First Amendment to the

**AMENDED AND RESTATED
ERCOT STANDARD GENERATION
INTERCONNECTION AGREEMENT**

**Dated
April 26, 2021**

**FIRST AMENDMENT TO THE AMENDED AND RESTATED
ERCOT STANDARD GENERATION INTERCONNECTION AGREEMENT**

Exhibit "C2"**One Line Diagram – TSP Interconnection Facilities, Generation Interconnection Facilities and the Plant**

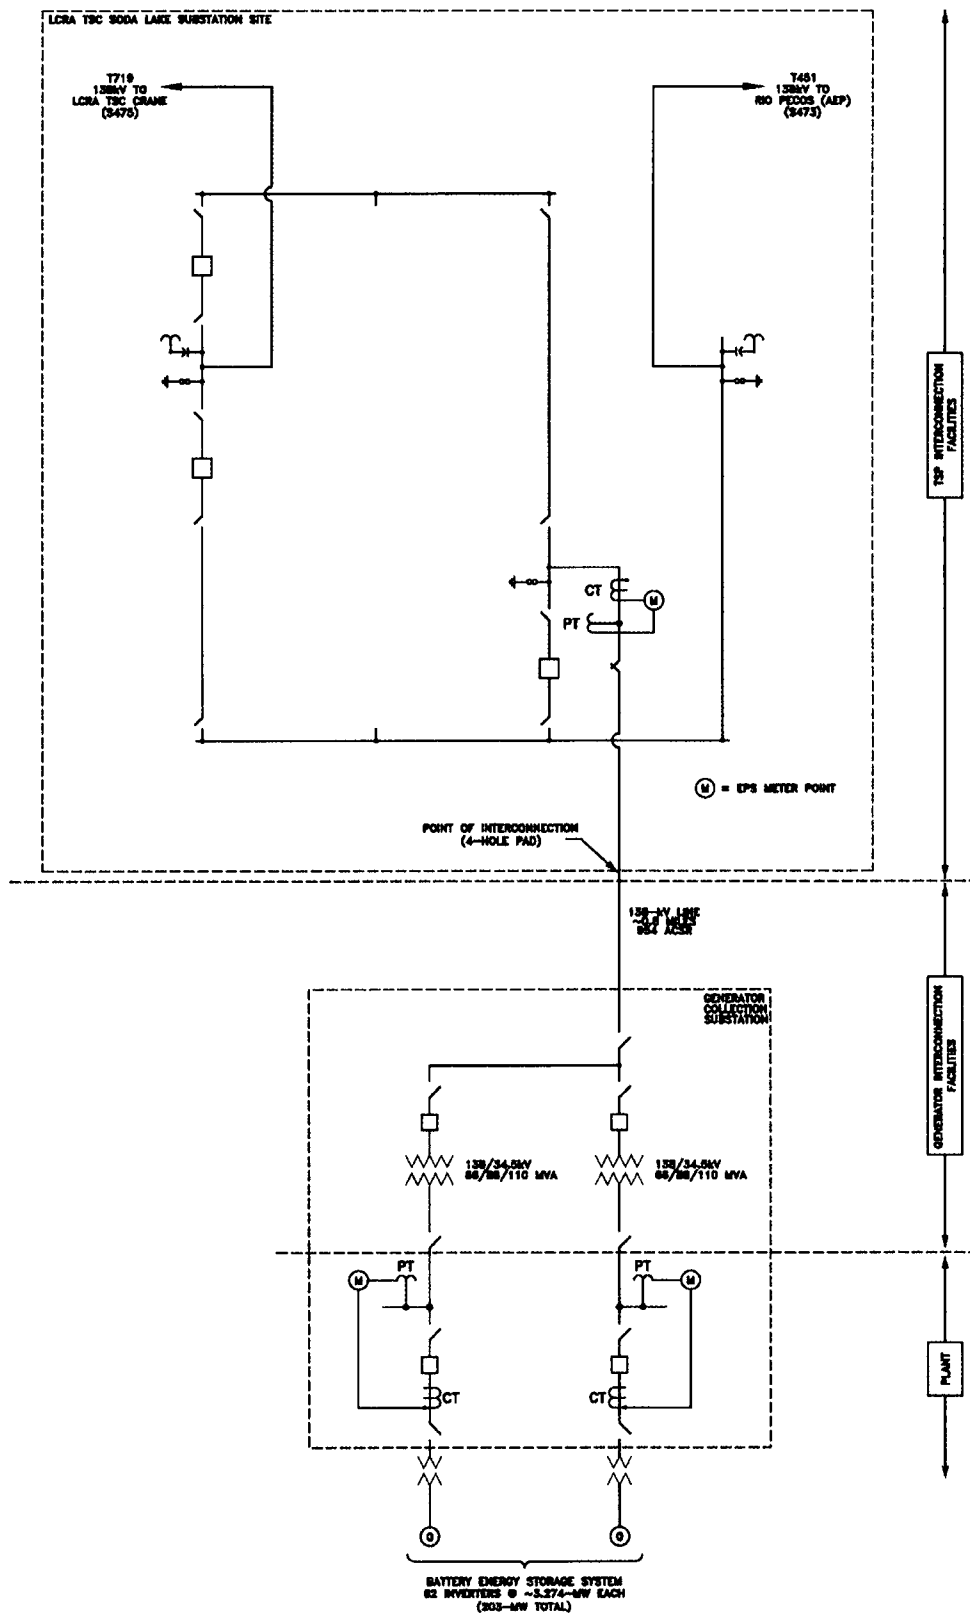
2. Exhibits "C", "C2", and "E" are deleted in their entirety and the Exhibits "C", "C2", and "E" attached to this Amendment are hereby added to the Agreement in lieu thereof.
3. This Amendment will become effective upon execution by both Parties.
